OEB STAFF INTERROGATORY 1

IESO-EWT/LSL-Staff-1

Ref: IESO's Addendum to the 2017 Updated Assessment for the Need for the East-West Tie Expansion; Reliability Impacts and the Projected System Costs of a Delay to the Project In-Service Date, dated June 29, 2018
Figure 1, Page 2

Figure 1 Expected Incremental Northwest Capacity Requirement under Reference Demand (2017 Update Report)

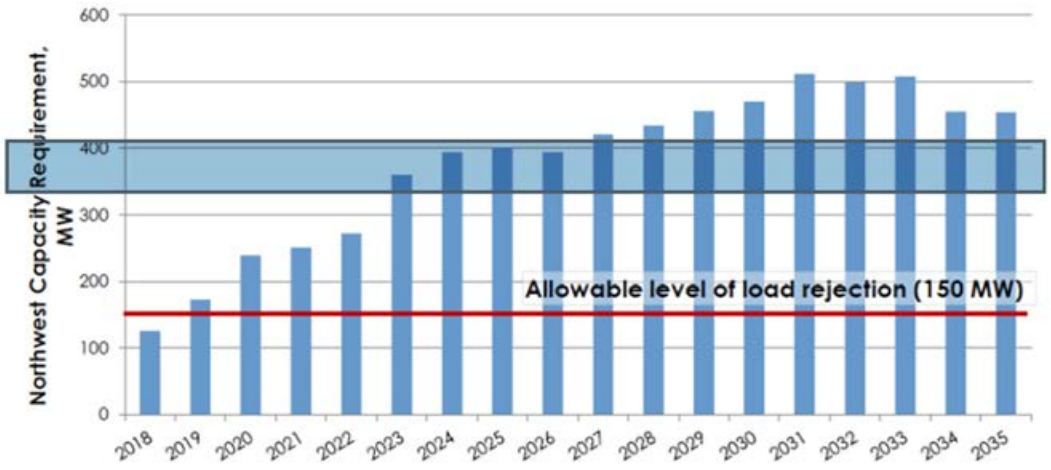
a) Has the IESO revised its peak demand forecast for the Northwest region since the last assessment update? If so, please provide an update to Figure 1.

Figure 2. Northwest Net Peak Demand Outlooks

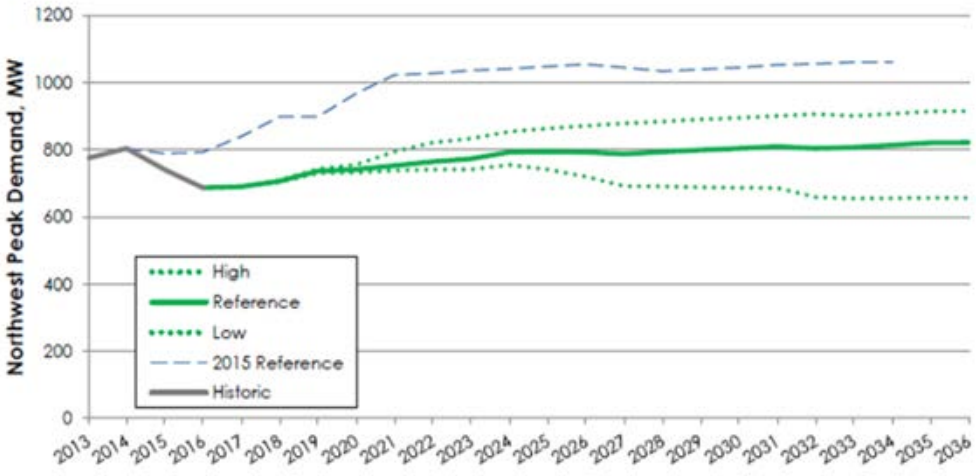
b) Forecast peak demand has declined materially since the 2015 Reference. Please provide evidence this trend has reversed since 2016, as per the Reference line in Figure 2.
